Subject: Preliminary Questions in Chapter 2 of the STP COLA
Sent Date: 3/11/2008 11:28:35 AM
Received Date: 3/11/2008 11:28:35 AM
From: Raj Anand

The following table represents a draft list of discussion items that will be discussed during the safety site audit for the STP Units 3 & 4 COLA FSAR Chapter 2. Additional items or changes may be added to the existing list, based on discussion and review.

Preliminary Information Needs for the STP Safety Site Audit

Figure 1
STP Stability Class Frequency Distributions

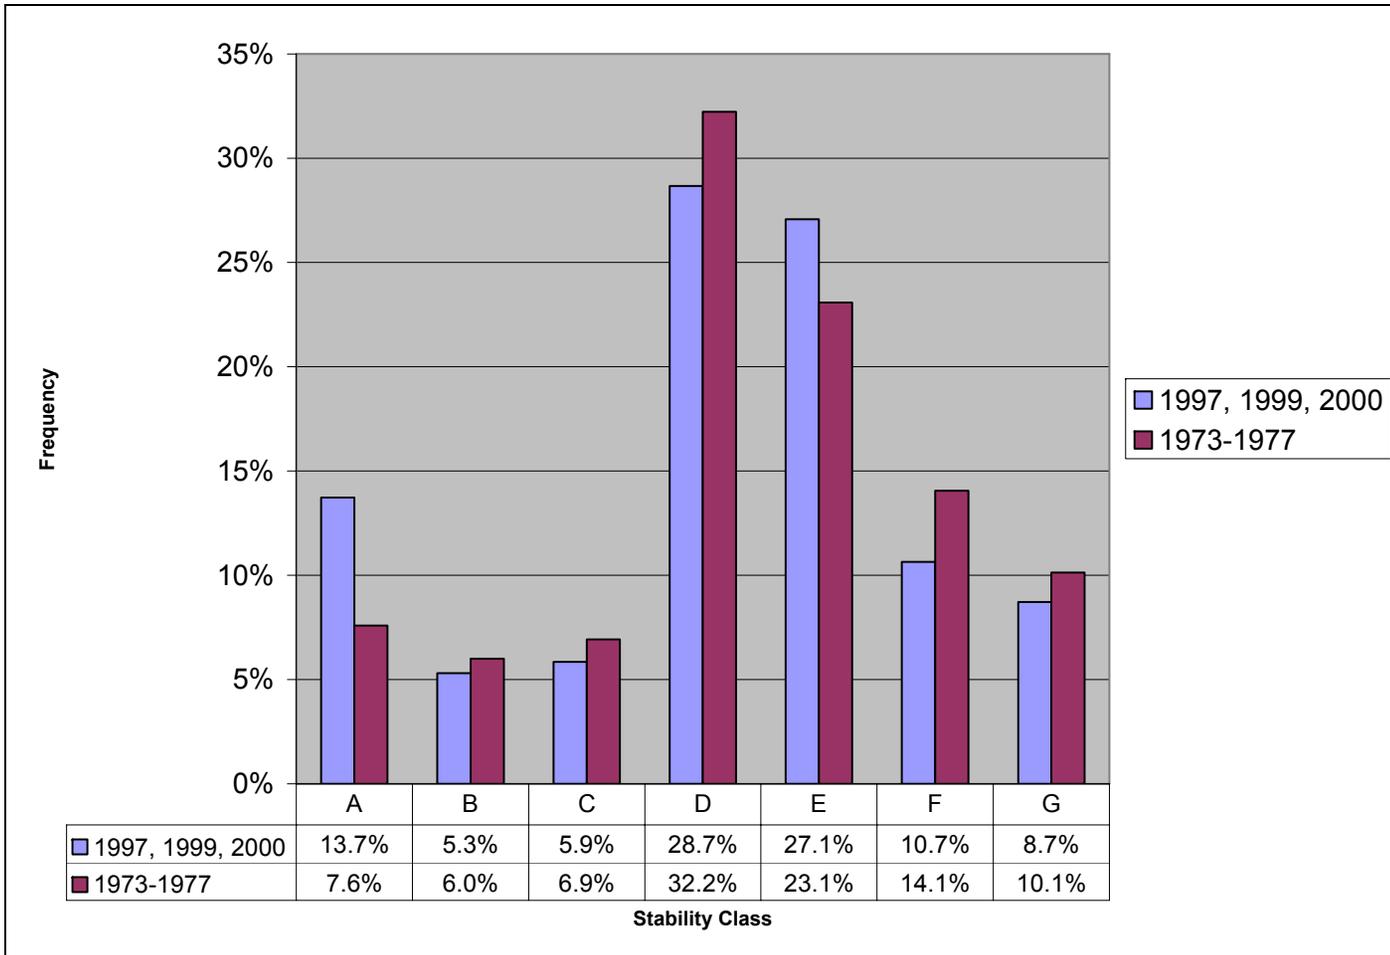
23.	2.3S3.4.1.2	Meteorology	Please explain the 6% increase of onsite A stability class frequency from the original data set (1973-1977) to the current (1997, 1999, and 2000) data set as shown in FSAR Table 2.3S-20 (see Figure 1).	Brad Harvey
